Re: Docket No. 461 - CSC 461 Greenwich Substation and Line Project

Response to OCC-04 Interrogatories dated 11/17/2015

**CL&P dba Eversource Energy**  
**Docket No. 461**

**Data Request OCC-04**  
**Dated: 11/17/2015**  
**Q-OCC-041**  
**Page 1 of 1**

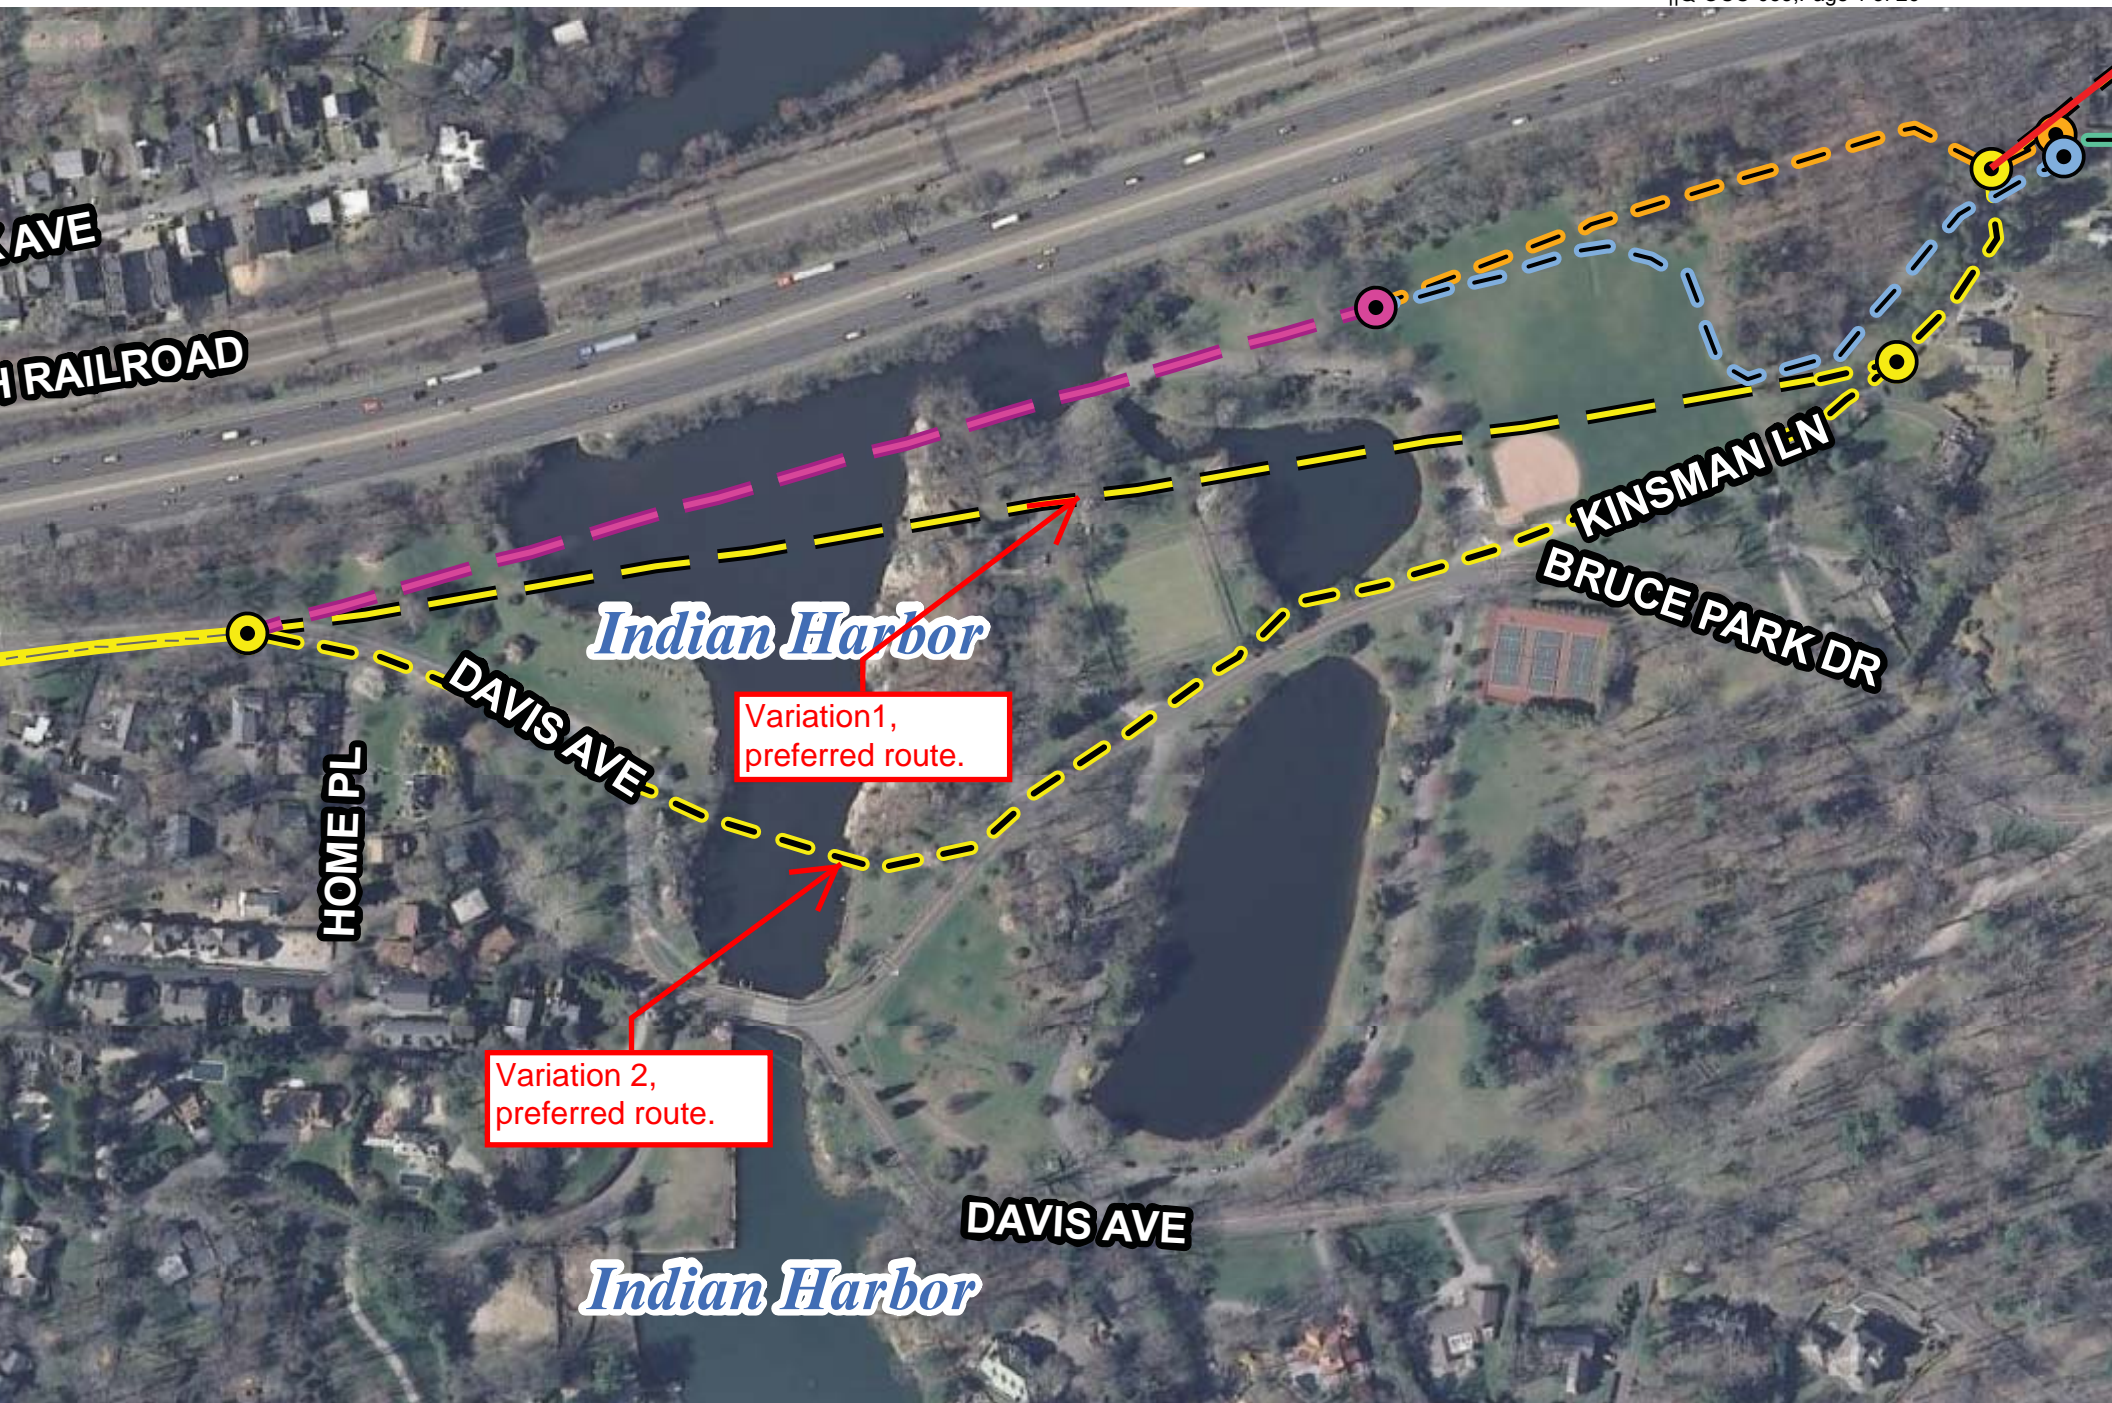
Reference Tr. of 10/06 at 207-208 and 221. At one point, the Company stated that it might have to do blasting in the Park, and at another point, it stated that the underlying soil is mostly sand and gravel. Provide a detailed explanation of the proposed construction and the geology of Bruce Park. Include a map of Bruce Park, mark out the areas where borings were done, and provide the results.

Both of the Company's statements are correct, depending on which route variation is under discussion. There are four (4) alternate routes for crossing Bruce Park, and based solely on the borings conducted to date, only the Orange section is a likely candidate for blasting. See attached file for route map and boring locations with logs in Bruce Park area. The underlying geology of Bruce Park is situated on an area with some surfacial bedrock and areas with bedrock covered by organic silt or sandy gravel overburden.

1) The Preferred Route option with Yellow variation 1 that includes some open trench and a horizontal directional drill (HDD) to cross beneath the park waterways; and Yellow variation 2, which involves open trench along Kinsman Lane and Davis Avenue and also utilizes a cofferdam to cross the park waterways. Based on the exploratory borings conducted to date, no blasting is expected.

2) The Blue route option, which extends through a grassy area of the park around the ball field to the entrance of a HDD that crosses under the park waterways. Exploratory borings indicate that open trench is a viable approach but complicated by a high water table. The HDD would be subject difficult drilling through the Harrison Gneiss bedrock found through the park. Based on the exploratory borings conducted to date, no blasting is expected.

3) The Orange route option, which follows along the I-95 corridor, includes a 500 foot section that extends up and over a wooded area of exposed ledge or shallow rock and then through a grassy area to the entrance of a HDD that crosses under the park waterways. Due to the relative isolation, the Orange route option is the one alternative that might be candidate for blasting.

It is expected that an open trench of minimum depth (since there are on crossings of foreign utilities) would be accomplished by drilling pilot holes into the rock ledge at 12-18 inch intervals in a grid pattern to the desired depth followed by fracturing the rock with a hydraulic / pneumatic rock hammer or by using blasting techniques, if required.

# Simplified Greenwich 13.2KV System Proposed Design

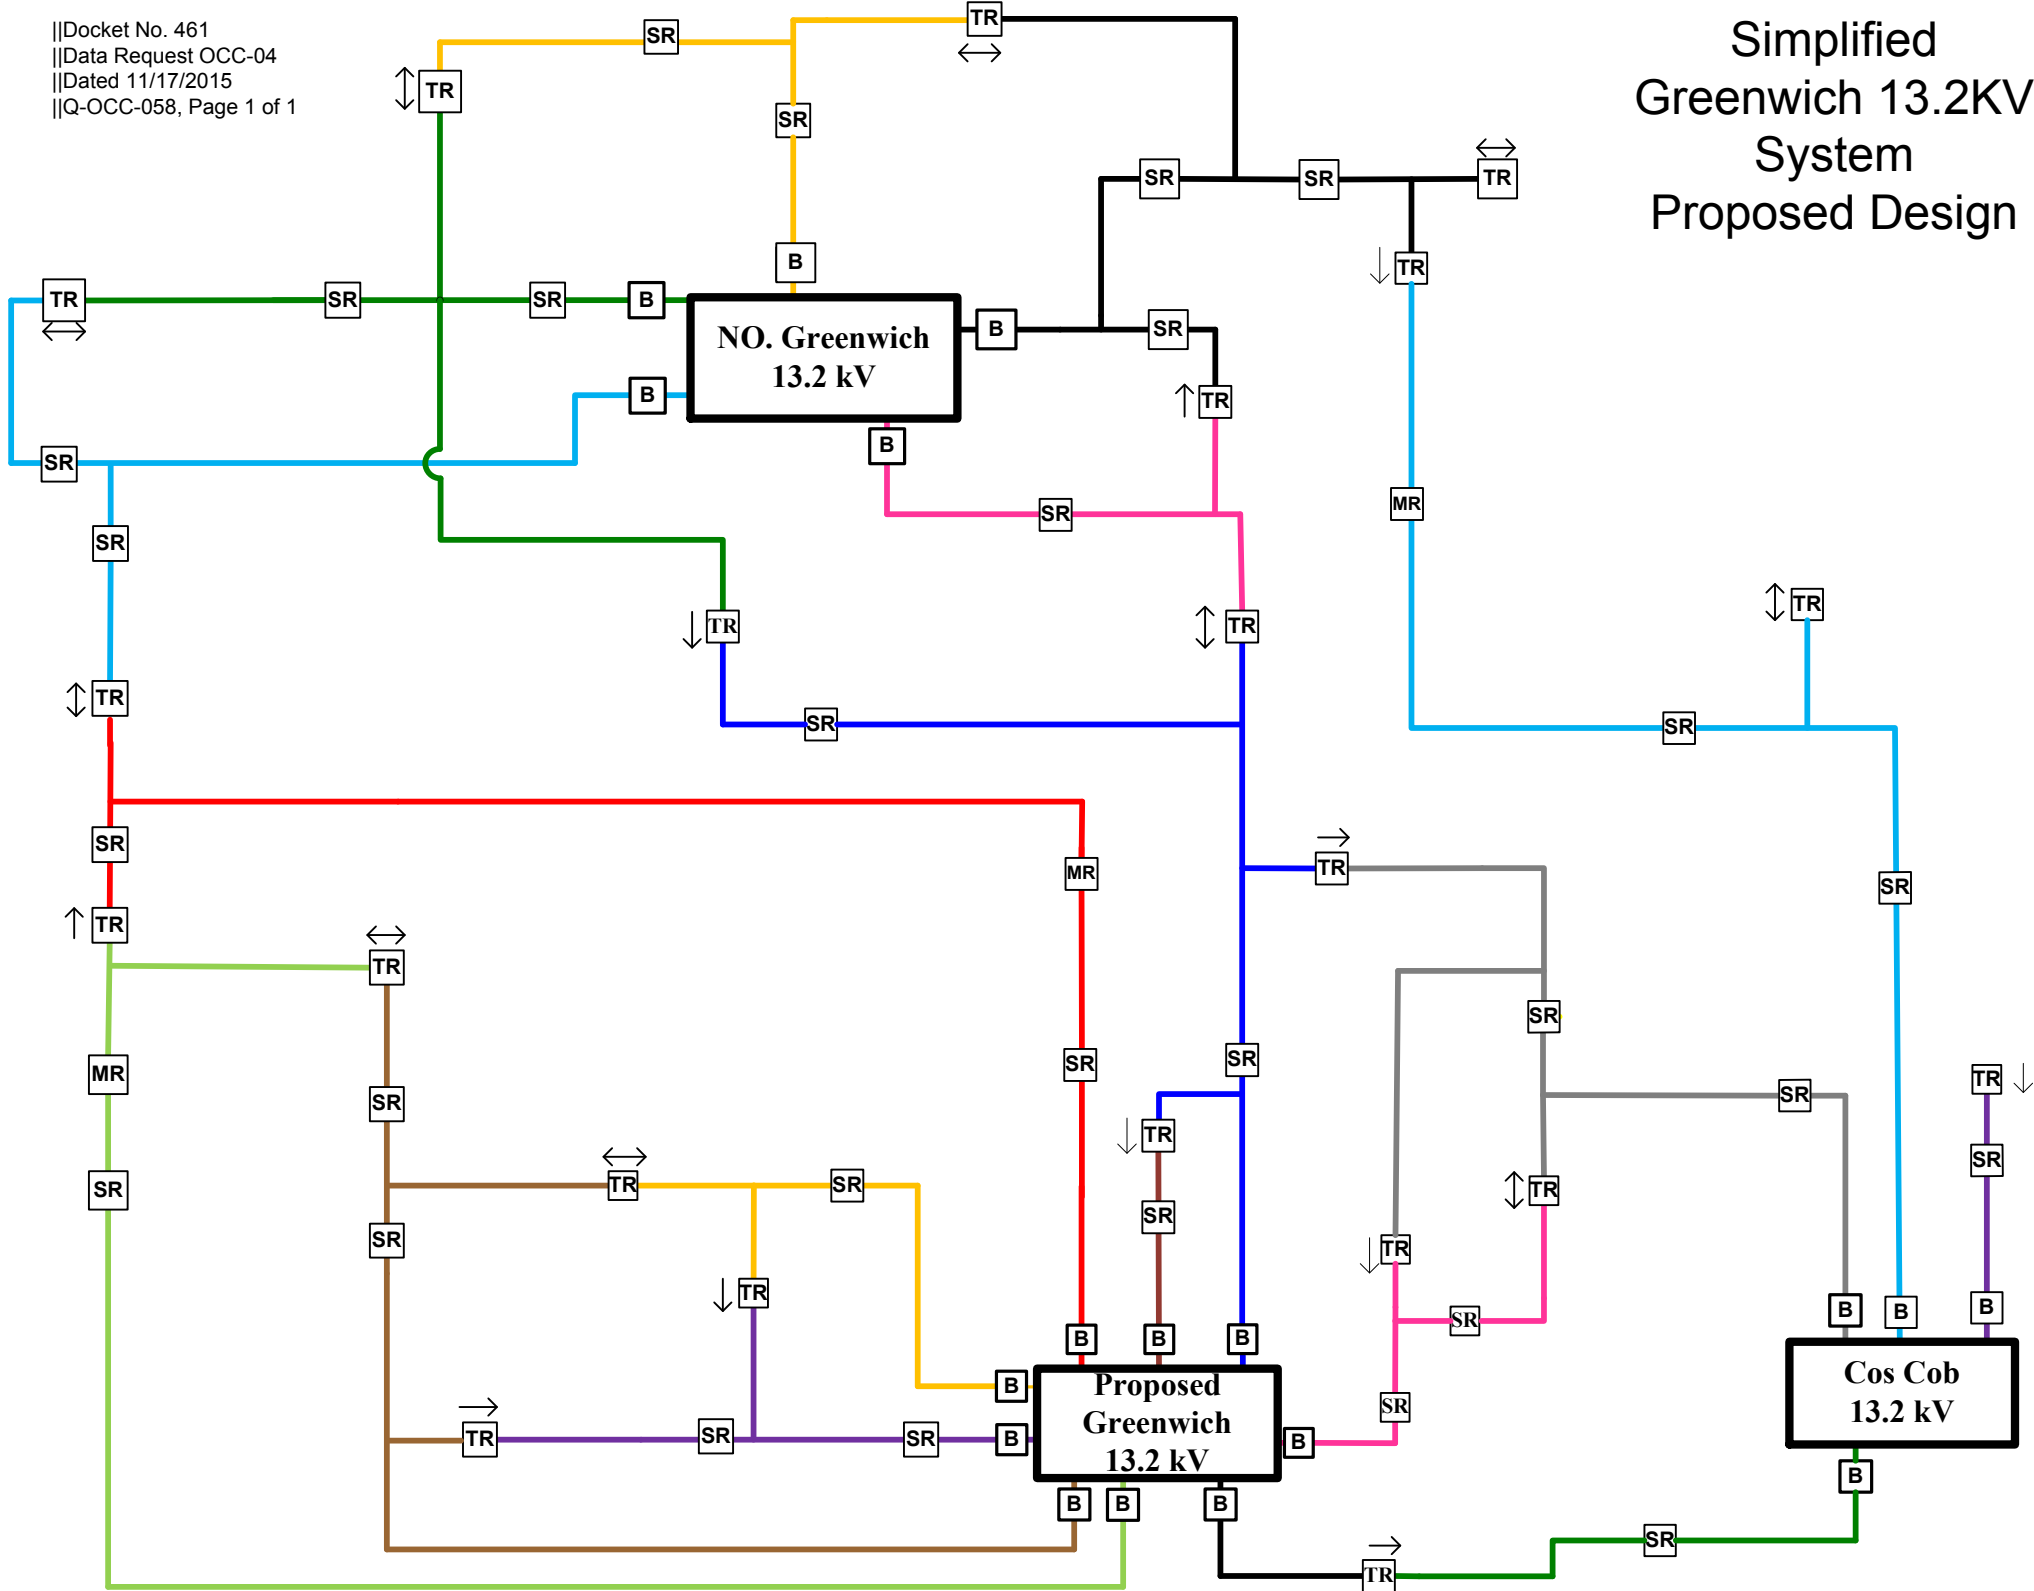
- (a) Define/describe planned feeder ties between the two substations.
- (b) Describe the impact on the Cos Cob substation and the proposed substation in the event that one or both of the 115kV circuits from Stamford failed at a location east of the Cos Cob substation.
- (c) In the hypothetical scenario where the proposed substation is in operation and there is a failure of the remaining 27.6 kV feeders originating from the Cos Cob substation, how would the Cos Cob loads be re-fed from the proposed substation? Detail a scenario whereby the North Greenwich substation would be energized to handle contingencies from the proposed substation.

- a) Please refer to the Simplified Greenwich 13.2 kV System Proposed Design attached. The Proposed Greenwich Substation would have six automatic loop scheme ties between feeders emanating from different buses at the proposed Greenwich Substation, four automatic loop scheme ties with Cos Cob Substation and three automatic loop schemes with North Greenwich Substation.

- b) If one of the two 115-kV transmission lines that feed Cos Cob Substation were to fail, there would be no impact to any of the customers fed by Cos Cob or Greenwich substations. If both of these 115-kV transmission lines were to fail, all of the customers fed by Cos Cob and Greenwich substations would be impacted.

- c) Under the proposed design, Cos Cob Substation would feed the Greenwich secondary network (five 27.6-kV feeders), the North Greenwich Substation (two Cos Cob Substation 27.6-kV feeders and one Prospect 27.6-kV feeder) and several Prospect commercial customers at 27.6 kV.
